BC HYDRO WANETA 2017 TRANSACTION EXHIBIT A-4

Re: British Columbia Hydro and Power Authority – Waneta 2017 Transaction Application – Project No. 1598933

INFORMATION REQUEST NO. 1 TO BC HYDRO

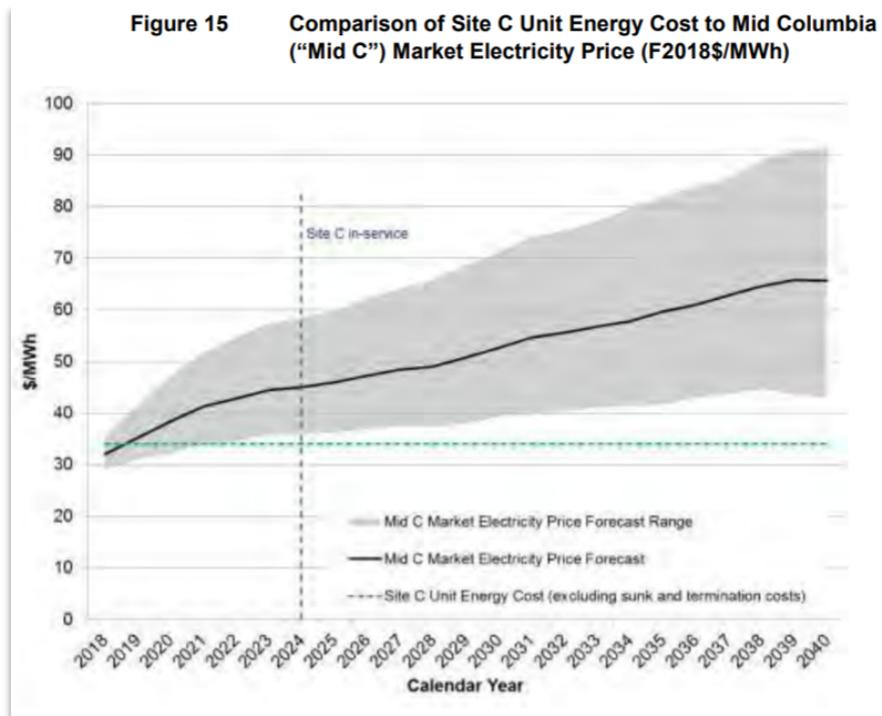
BC Hydro submitted the following figure in the BCUC Site C Inquiry proceeding:

7.7 Please extend this graph to F2058 and provide assumptions.

7.8 Please add to the above graph, for F2018 to F2058, BC Hydro’s Extrapolated Prices and the Panel Mid-C energy price forecast found at page 95 of the Site C Final Report.

7.9 Please add Waneta UEC during and post Lease.

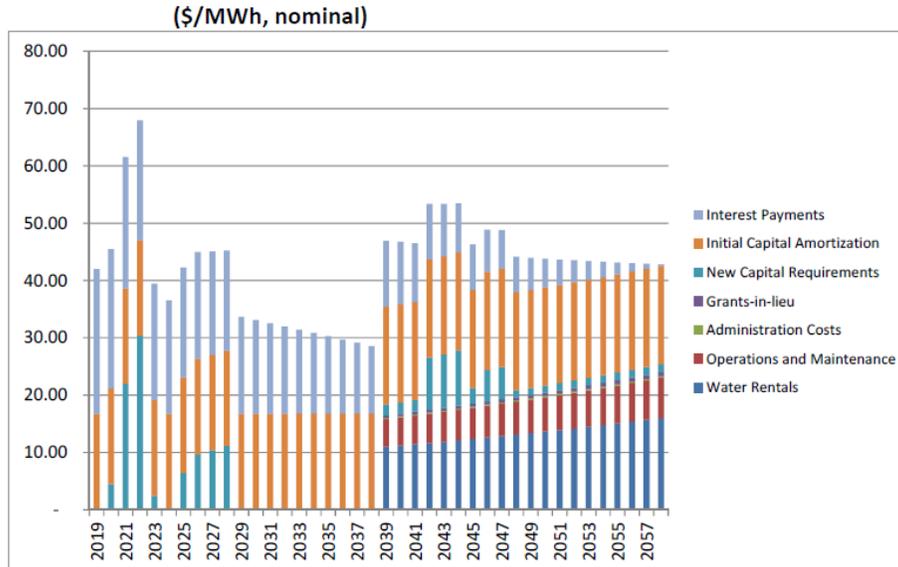
On page 15 of the Business Case, BC Hydro provides Figure 1 below showing the operational cost of service for the 2/3 Interest.

15.7 Please clarify why the NPV of the 20-year lease only takes into account the administration costs, and not the other components of the cost of service as shown in Figure 1 above (e.g., new capital requirements).

Figure 2-3 Regional Generation and Transmission Facilities - Current⁶⁰

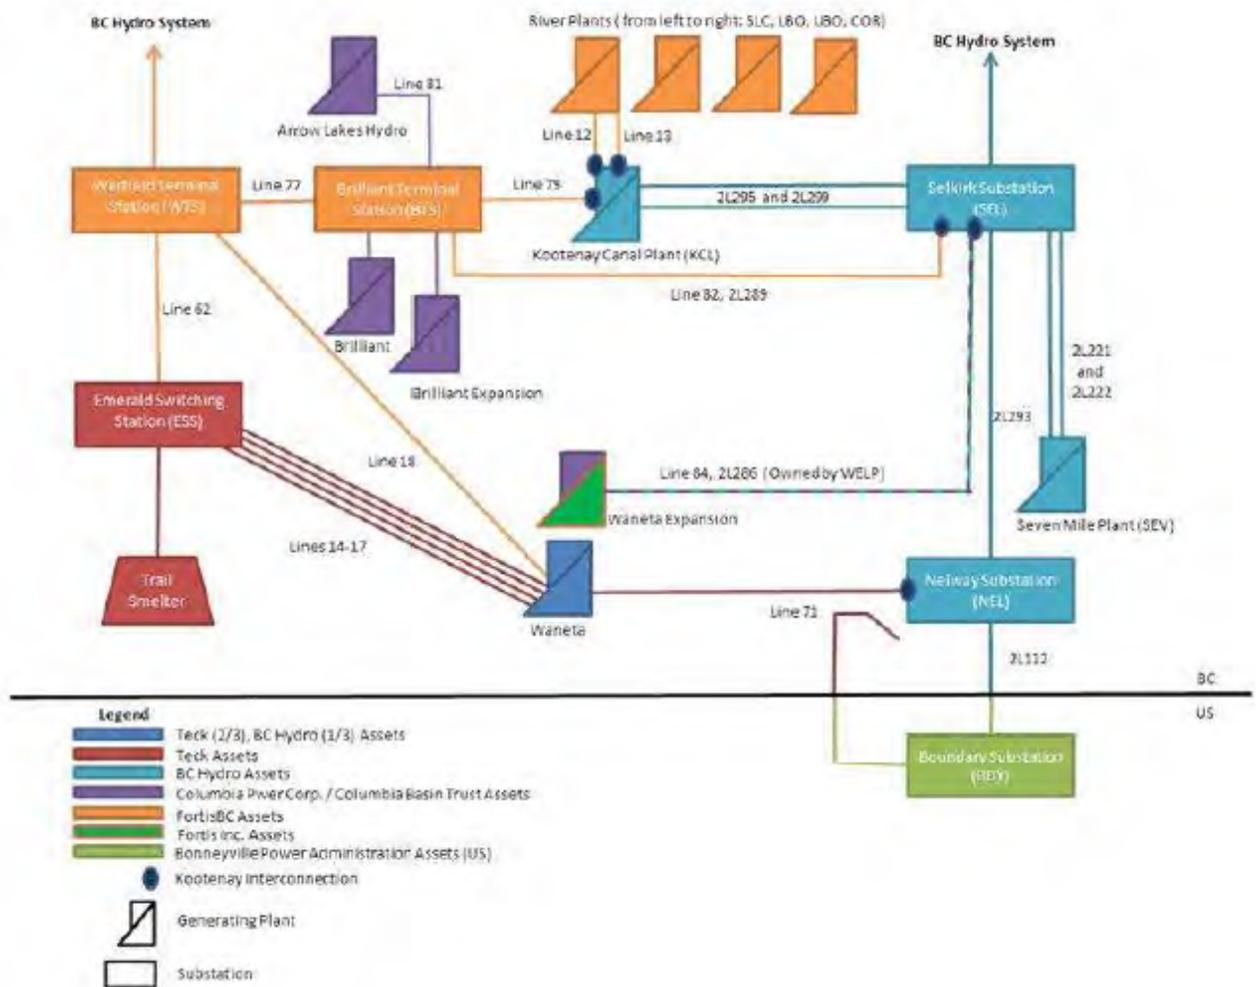
- 41.3 Please discuss any risks to the transaction, with respect to cost and access to the transmission required over and above Line 71's capacity.
- 41.4 How and where does the line in the top left corner of Figure 2-3 connect to BC Hydro's transmission system? Please explain.

- 41.5 Please elaborate on the FortisBC transmission lines shown in Figure 2-3, including the un-numbered transmission line in the top left corner of the figure including, but not limited to, rating, directionality and purpose.
